#### **PD Modification Application:** MM 24-1152

**Development Services Department**

#### **1.0 APPLICATION SUMMARY**

2.5 Proposed Site Plan (partial provided below for size and orientation purposes. See Section 8.2 for full site plan)

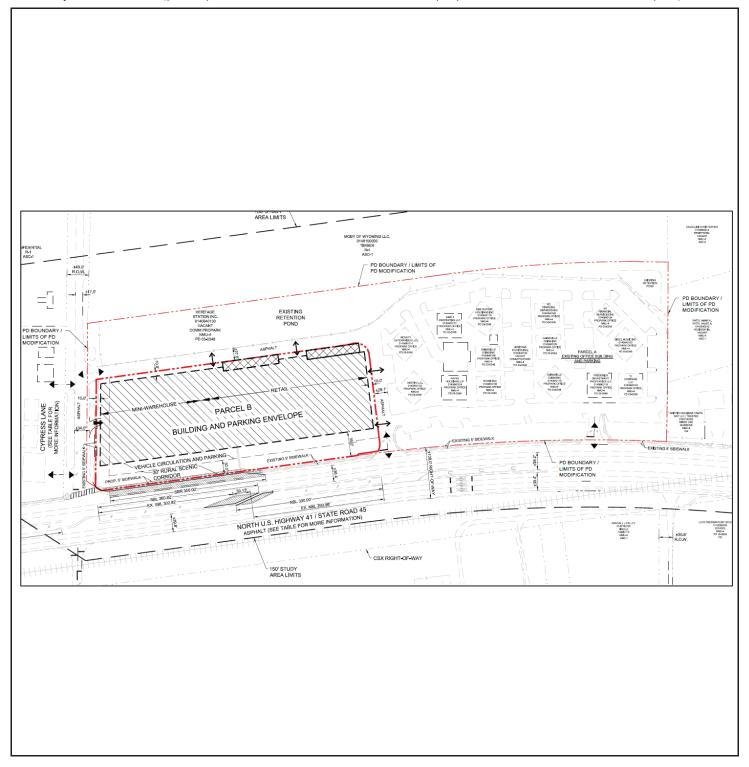
Both the Lutz Rural Development Standards and conditions of approval limit building size to 20,000 per building. As part of this modification request, the applicant proposes to allow only the mini warehouse building to exceed 20,000 sf per building. Given the building form of a mini-warehouse use, the layout of several 20,000 sf buildings would not look significantly different than one single building. At the proposed location, the subject building is separated from the west by screening and retention areas. Additionally, the site is located along US Hwy 41 (an eight lane roadway), which a larger building would not appear to be out of scale with the immediate area. All other building design and parking location requirements of the Lutz Rural Development Standards will be met.

FIGURE 1

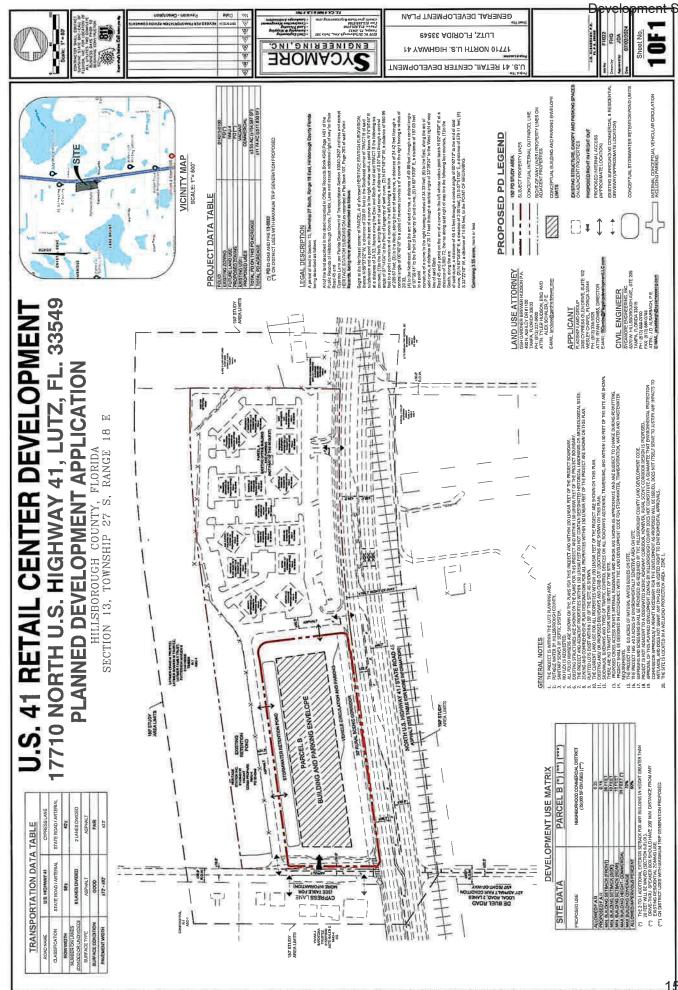
- 1. The developer proposed to add the following improvements to Cypress Lane:
  - a. Restripe Cypress Lane from US 41 to the western access to provide 11 foot lanes and 6 foot bike lanes.
  - b. Provide 5 foot sidewalk on the north side of Cypress Lane.

Figure 1 illustrates the proposed improvements and Figure 2 illustrates the proposed typical section.
